RESPONSE TO REQUEST FOR ADDITIONAL INFORMATION

APR1400 Design Certification

Docket No. 52-046

RAI No.:	**416-8358**
SRP Section:	**SRP 19**
Application Section:	**19.1**
Date of RAI Issued:	**02/23/2016**

Figure 19.1-36 Level 1 Event Tree - Total Loss of CCW (TLOCCW)

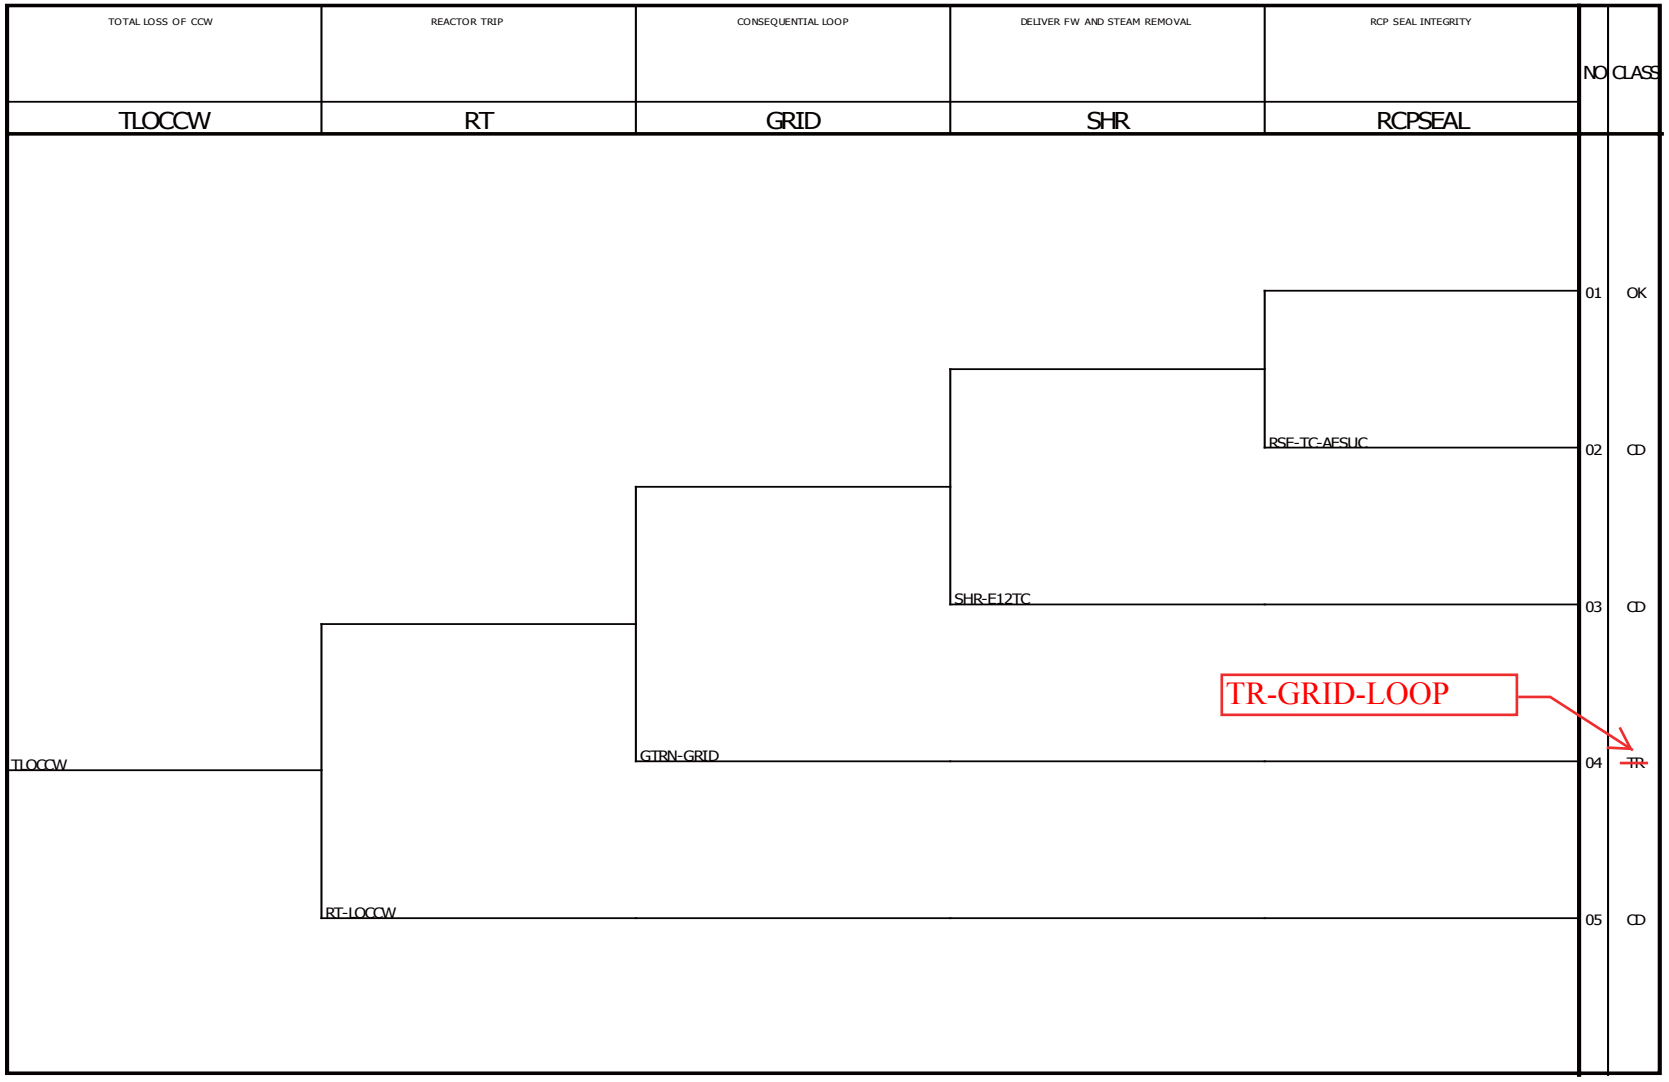
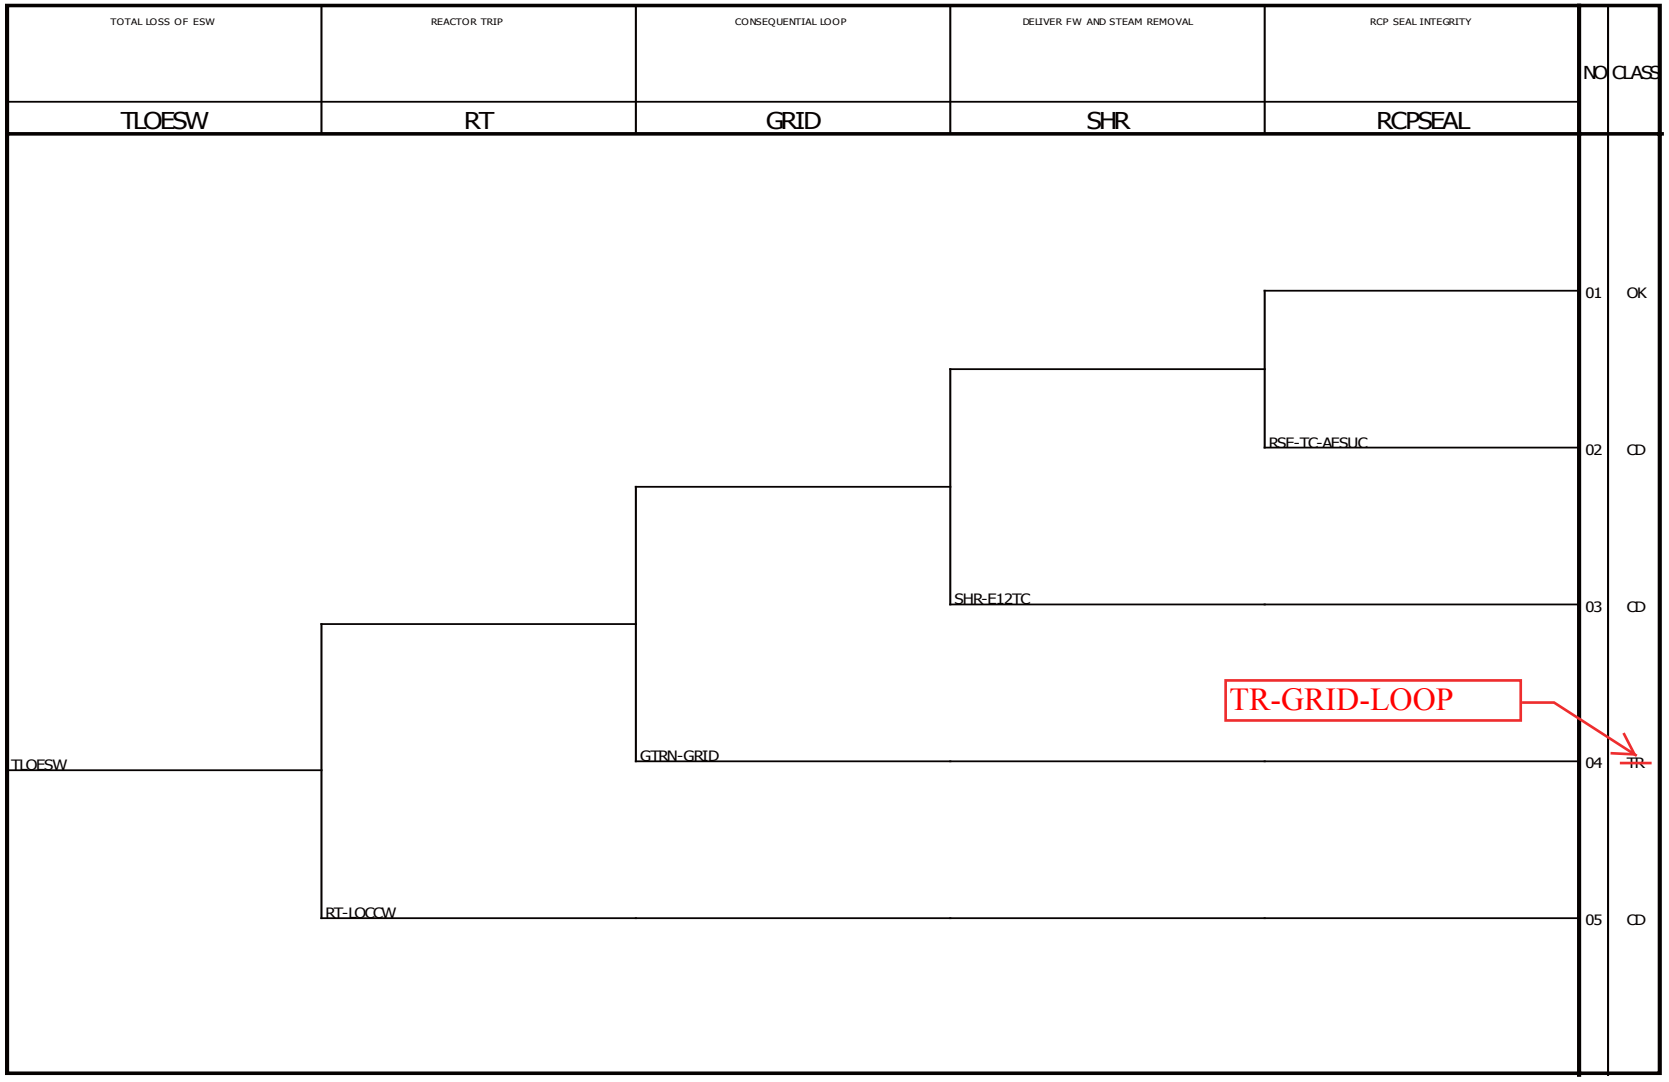
2 The transfers shown in the event trees to not identify the trees they transfer to

2. The pictures of the event trees provided in the DCD with transfer sequences will be revised to identify the event tree to which it is being transferred. Attachment 2 contains the revised event tree pictures.

The revised pictures include an identifier to indicate to which event tree the sequence is transferred. Obviously, transfer sequences which include failure of reactor trip transfer to the ATWS event tree (TR-ATWS), transfer sequences which include stuck open POSRVs transfer to the stuck-open POSRV event tree (TR-PR-SL), transfer sequences with include consequential LOOP transfer to the consequential LOOP event tree (TR-GRID-LOOP), LOOP sequences with failure of all DGs transfer to the SBO event tree (TR-SBO) , and finally GRID-LOOP sequences with failure of all DGs transfer to the GRID-SBO event tree (TR-GRID-SBO).
